# JCLA MARK UP

KL037.F.02.TP\_ 050917

**PLANNING CONDITION ISSUE**

**Project** Kingsgate Liddell  
**Project No.** KL037  
**Client** London Borough of Camden  
**Date** 5th September 2017  
**Scale** 1:250 @ A1  
**Drawing Name.** Tree plan  
**Dwg No.** KL037.F.02.TP

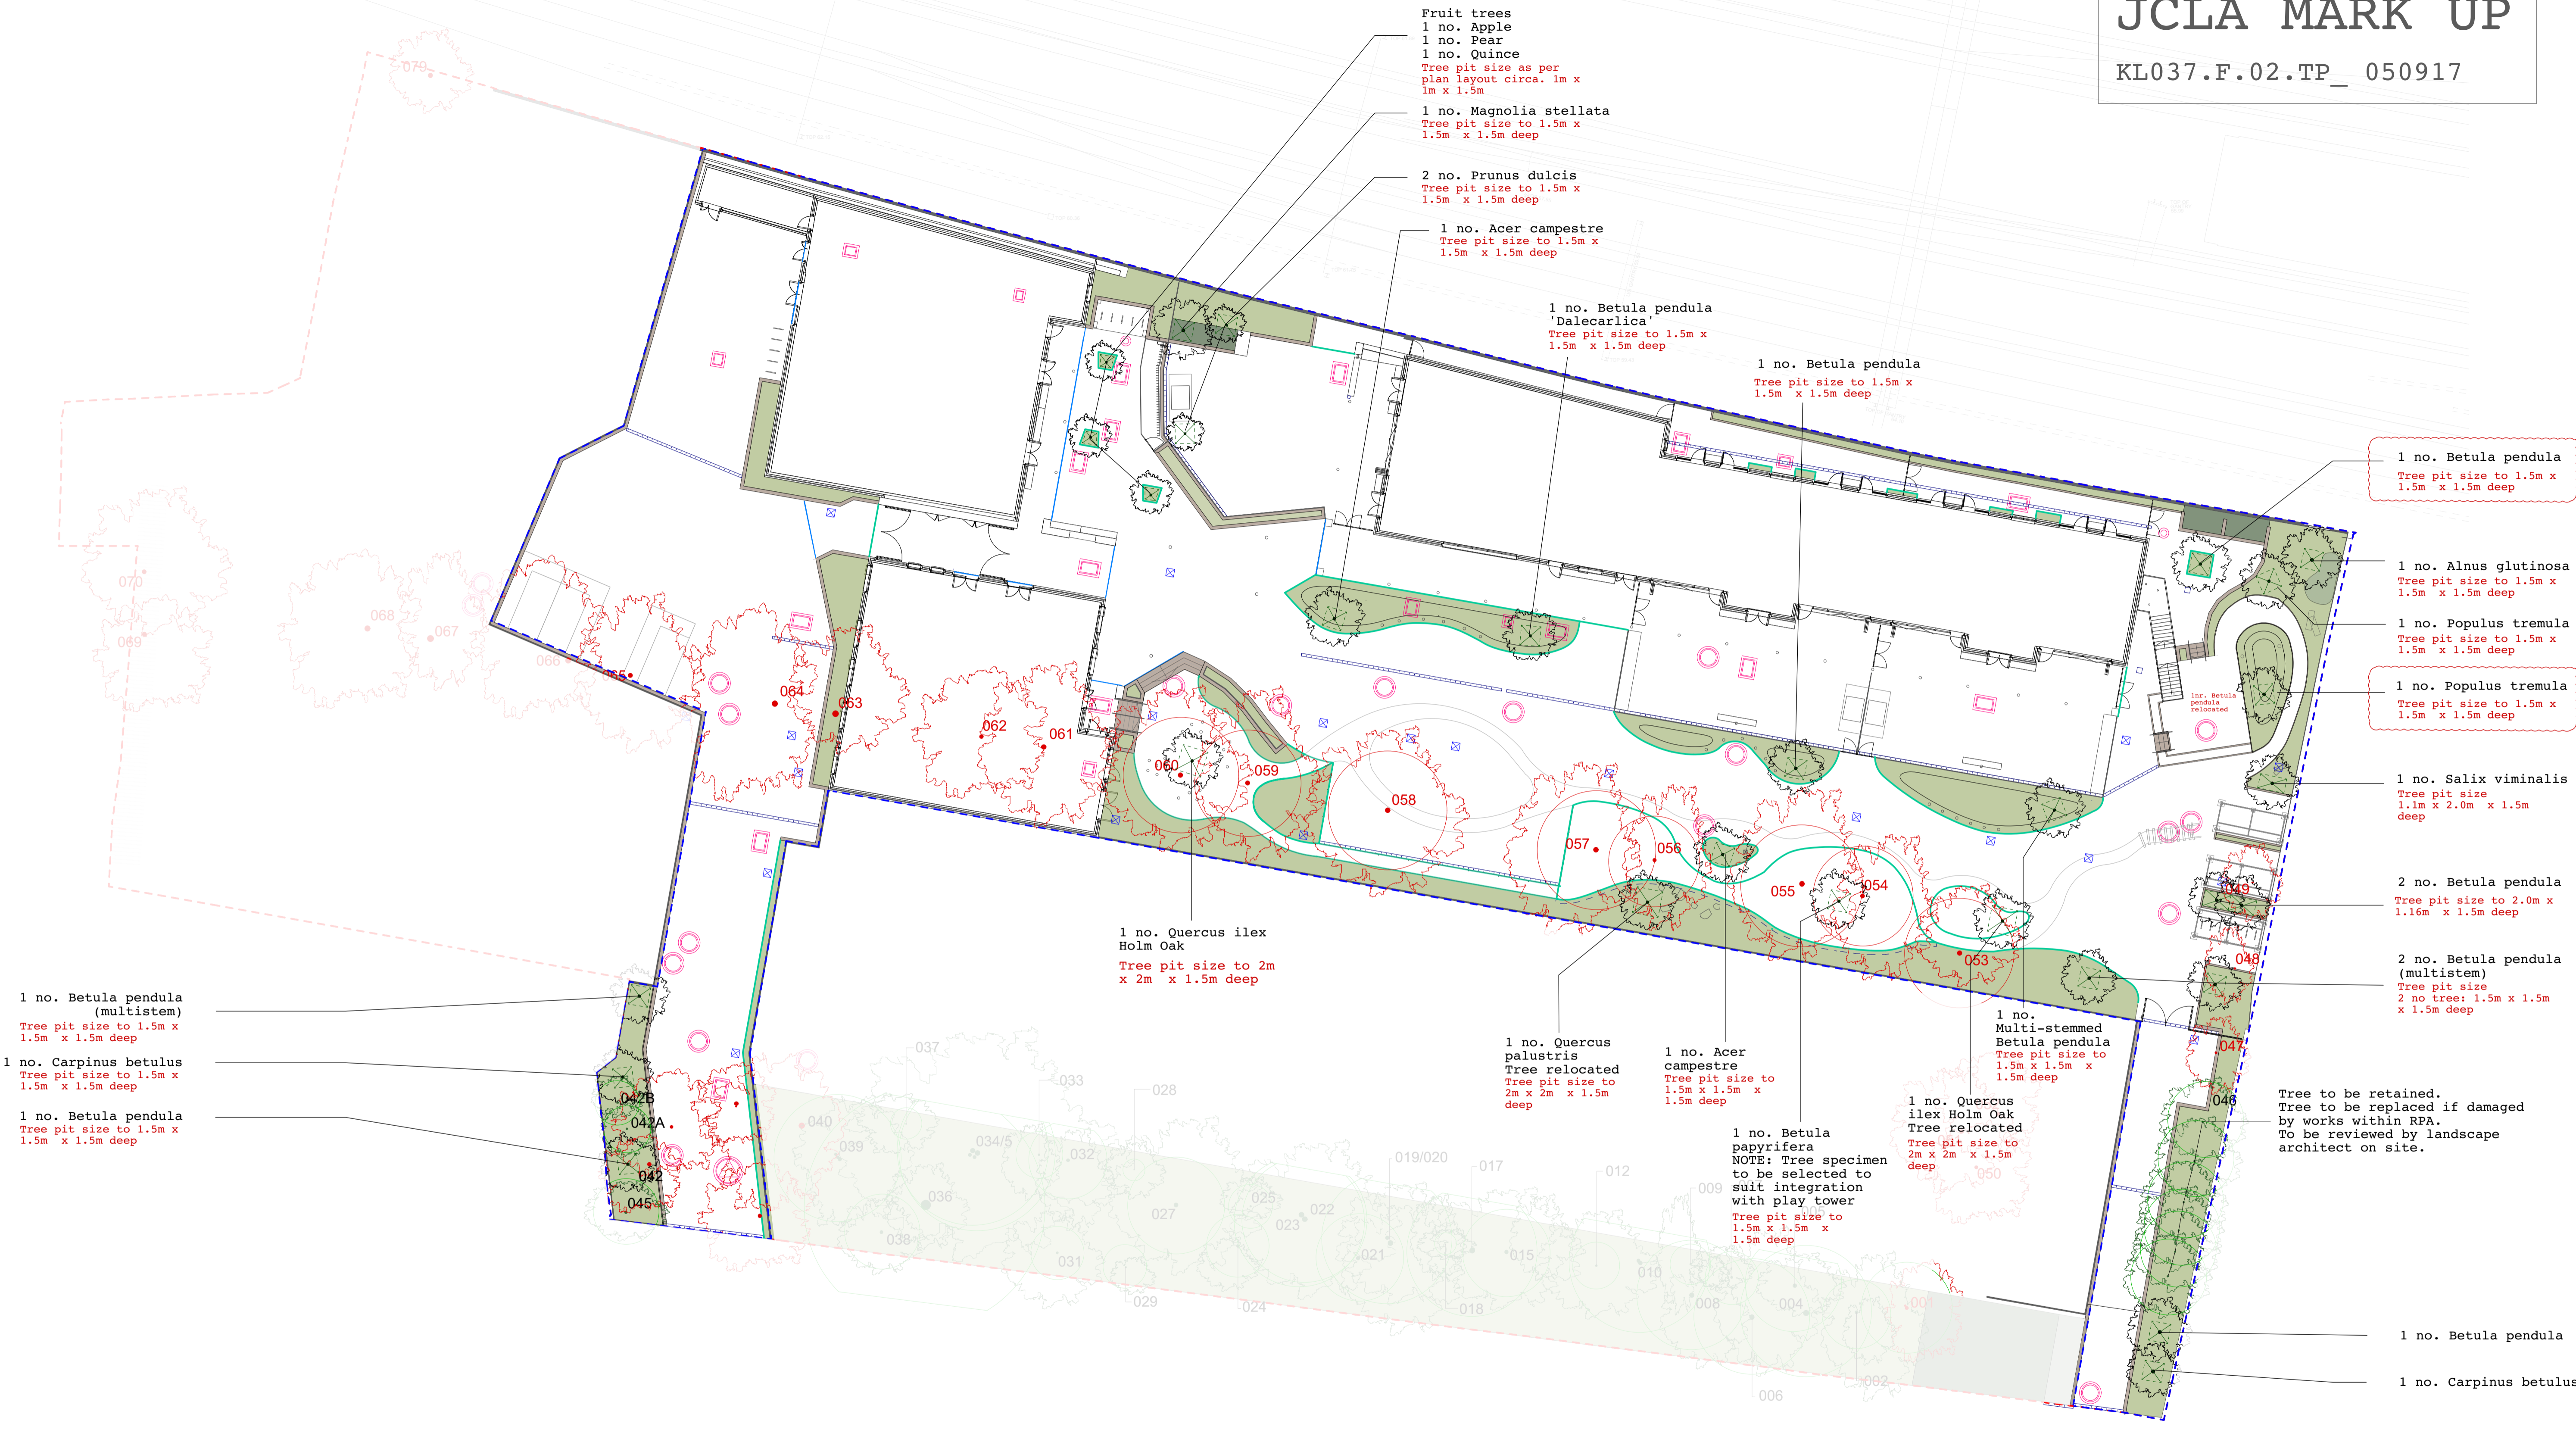
**Revisions**  
Revision (MARK UP FOR REVIEW):  
- 1no. *Populus tremula* adjacent to railway line NE corner swapped position with 1no. *Betula pendula* in science garden area.

Bubbles key  
Changes
